Request: BUILDING PERMIT

Address: 830 Discovery Ln

9-A-24-TOB

A NEW BUILDING FOR
HARRISON BEND PROPERTIES, LLC
830 DISCOVERY LN
KNOX COUNTY, TN 37932
9-C-24-DP

SITE GRADING PLAN

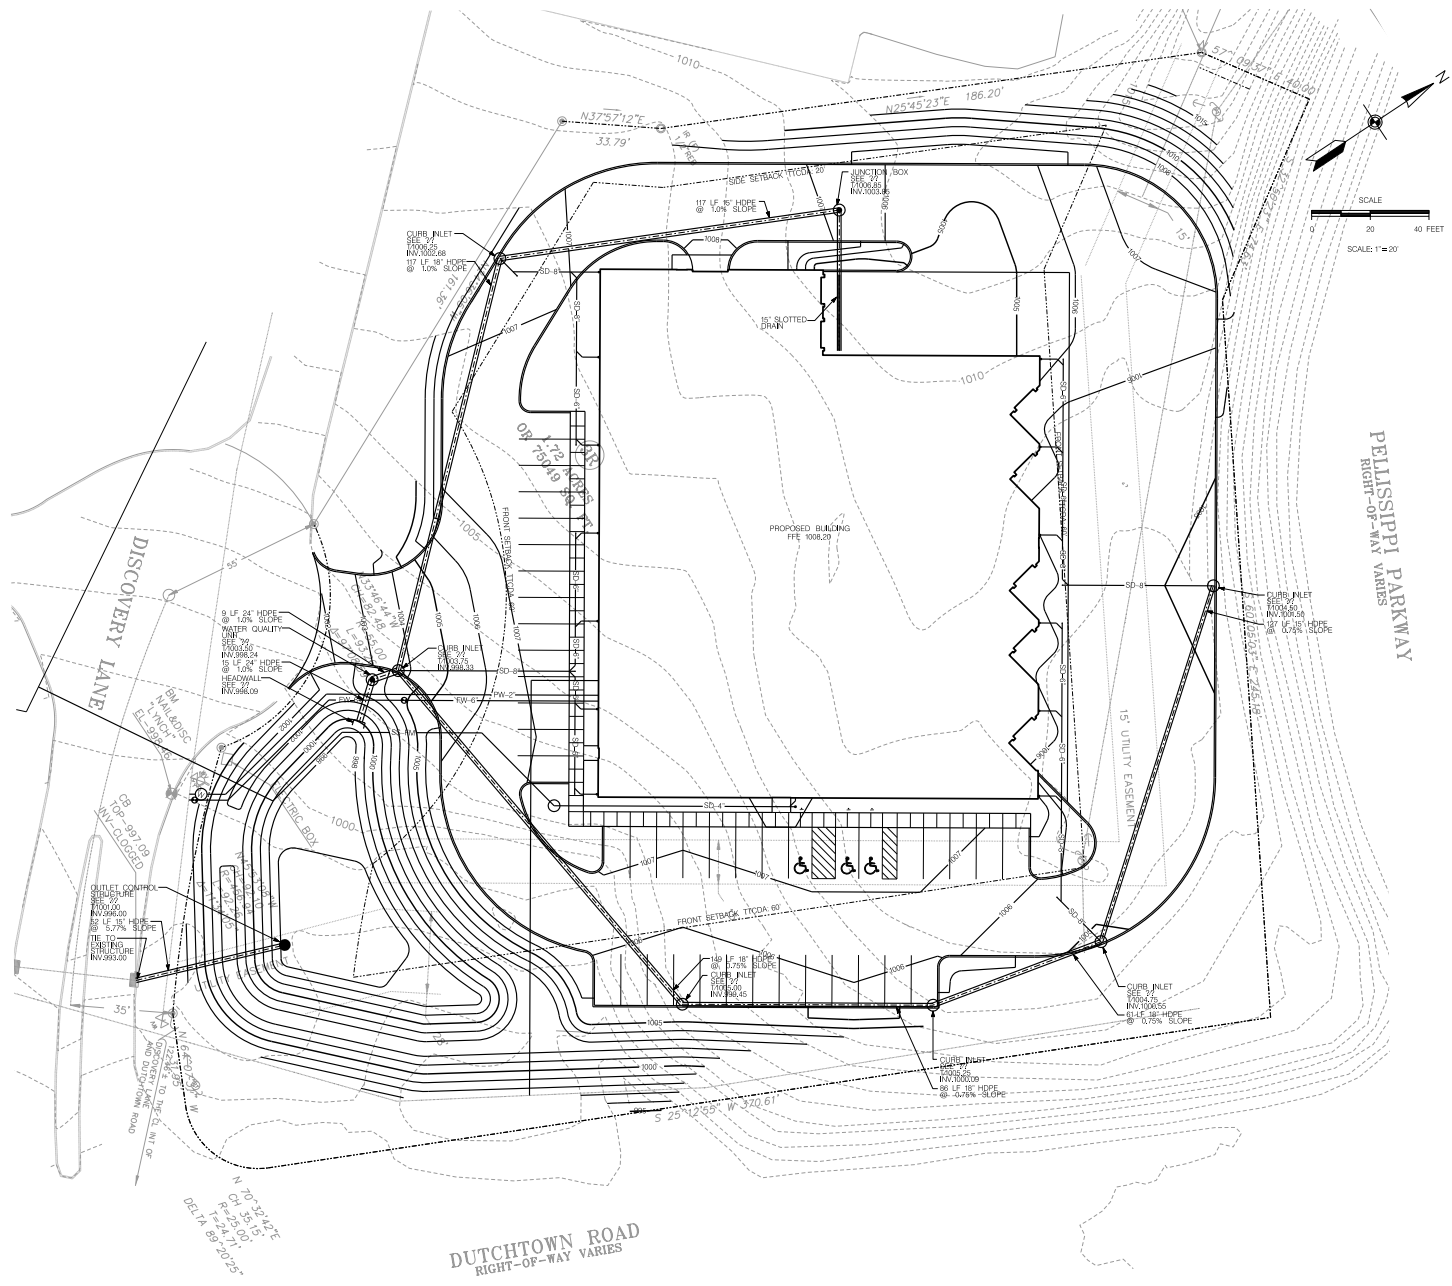
1. Knox County has no comments on this proposal.
2. There is a KUB gas line where the detention pond is located. The relocation issue will be discussed with KUB during permitting. If the site needs to be redesigned, this could require another approval by Tennessee Technology Corridor Development Authority (TTCDA) and Planning Commission.

- 1) Resolving the location of the KUB utility lines prior to the issuance of a grading permit. Redesigning the site could require TTCDA and Planning Commission approval.
- 2) If during design plan approval or construction of the development, it is discovered that unforeseen off-site improvements within the right-of-way are necessary, the developer will either enter into an MOU with the County for these improvements or reimburse the County for their direct expenses (if completed by County crews) to make corrections deemed necessary.
- 3) Meeting all applicable requirements of the Knox County Engineering and Public Works and Knoxville Utility Board.
- 4) Meeting all other applicable requirements of the Knox County Zoning Ordinance.
- 5) Obtaining Planning Commission approval of the development plans (Case# 9-C-24-DP).

Landscape Plan

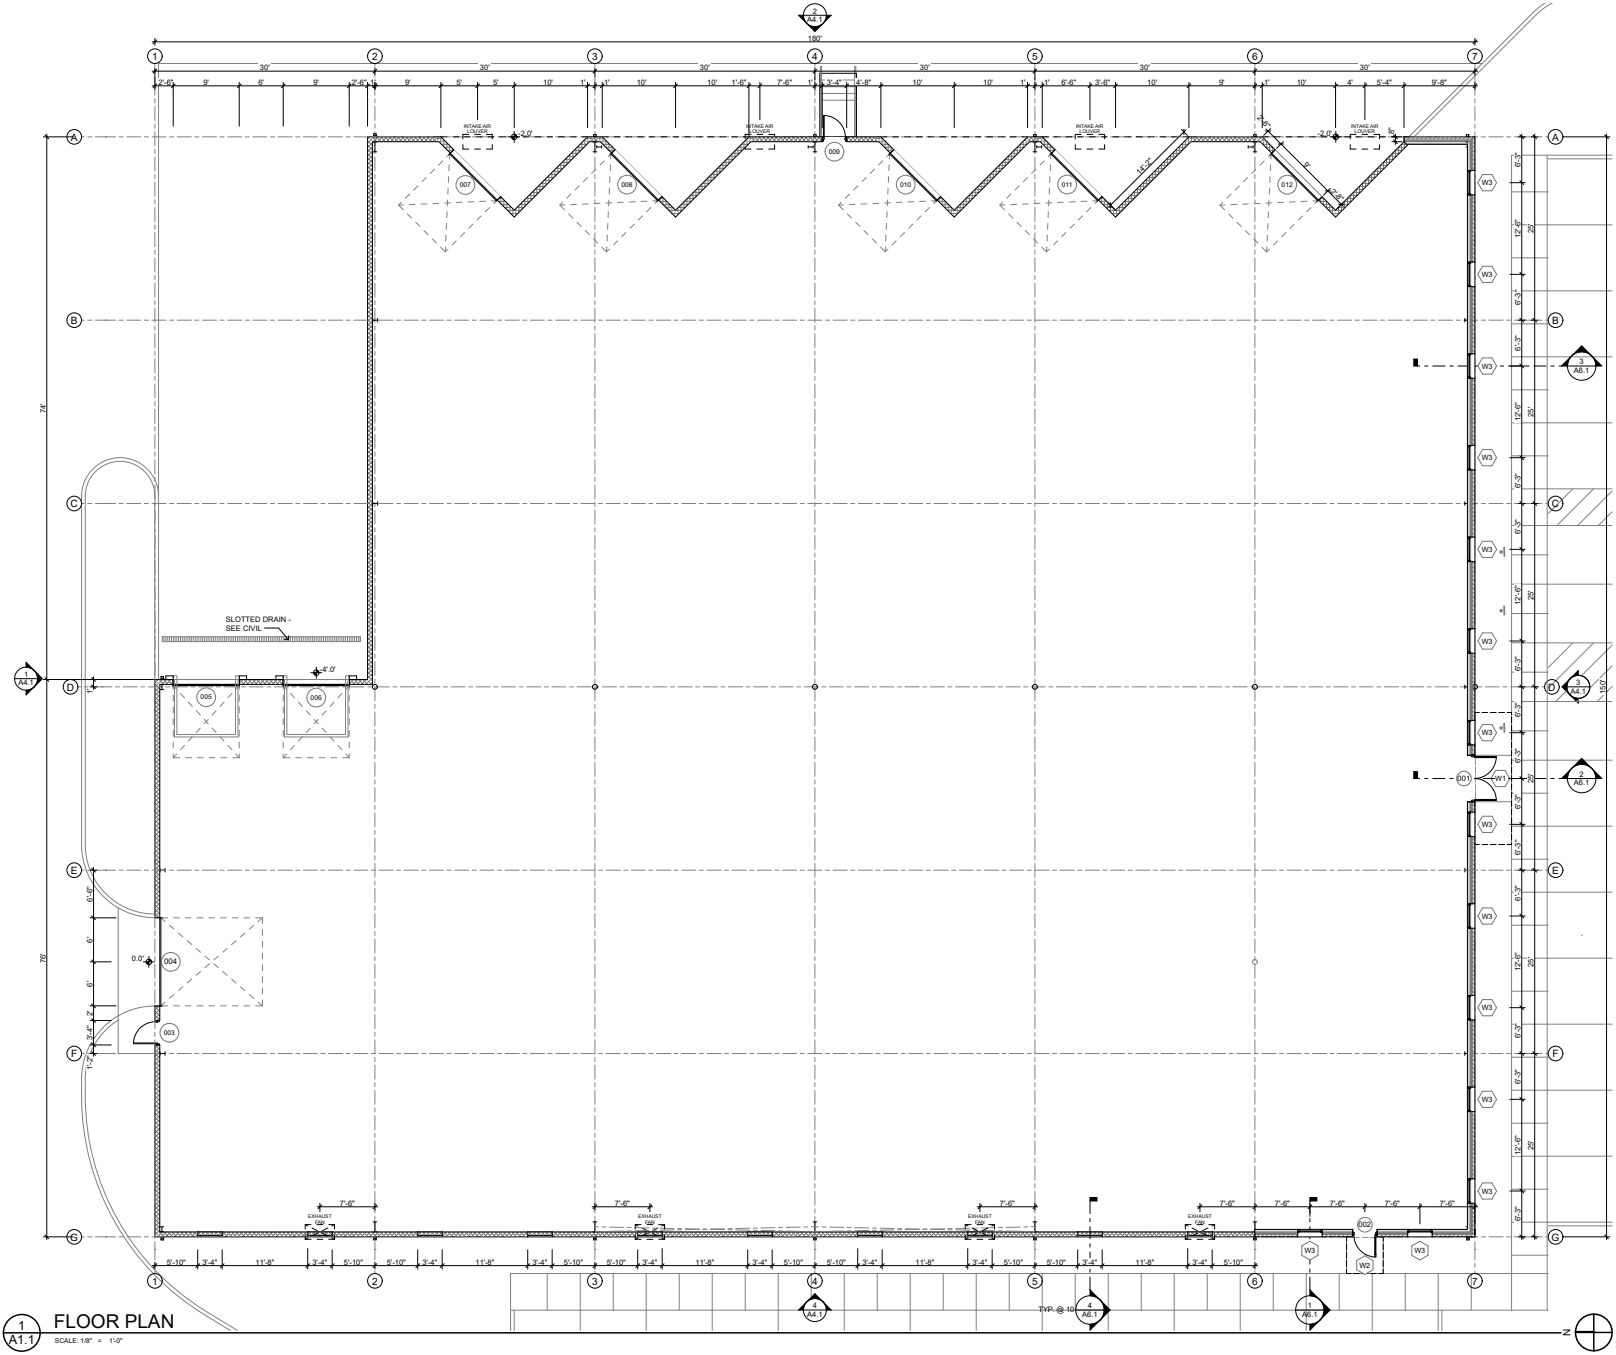
4. The applicant is requesting a waiver to Section 3.1.8, the required 20 ft landscaped yard on Pellissippi Parkway side. – There is an existing tree line with a berm in the Pellissippi Parkway right-of-way and the other 2 front yards meet the landscape guidelines. All other landscape guidelines have been met including planting around 50% of the building and landscaping at the site entrance and building entrances.

- 1) To waive the 20 ft landscaped yard on the east side fronting Pellissippi Parkway because of the existing berm and tree line along the Pellissippi Parkway right-of-way.
- 2) To exceed the maximum number of parking spaces by 9 spaces, if pervious pavement is used.

EXTERIOR ELEVATIONS

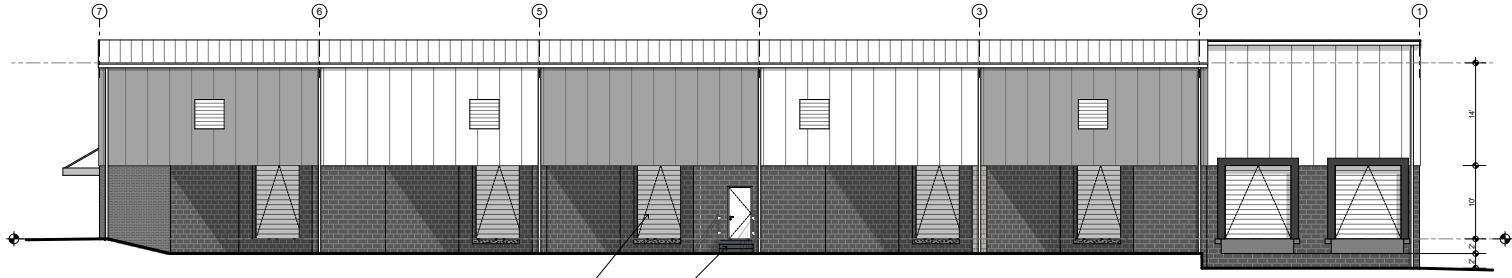
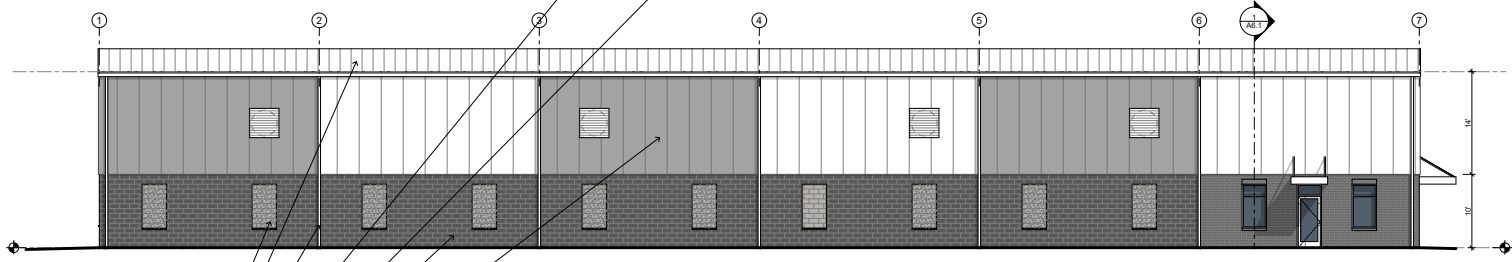
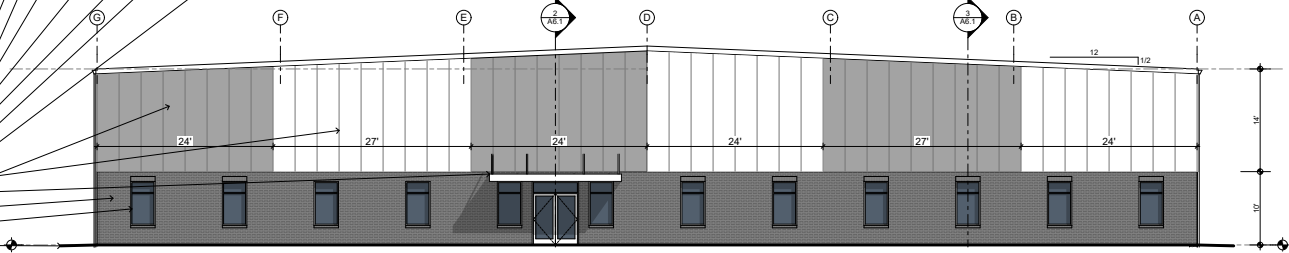
2. The office/warehouse building will be one story and is approximately 24 ft tall. The proposed materials consist of dark grey brick veneer and white and grey alternating insulated metal paneling, which is compatible with the other brick buildings in the business park. The roof is a silver standing seam metal roof. The Dutchtown Road elevation has the main entrance centered just off to the west and has an aluminum storefront window system with white frame and grey tinted windows. The Discovery Lane elevation has an entrance on the far east end and the faux recessed windows with smooth plaster finish inset light grey aluminum windowsill to emulate look on Dutchtown. Both entrances will have white aluminum canopies.
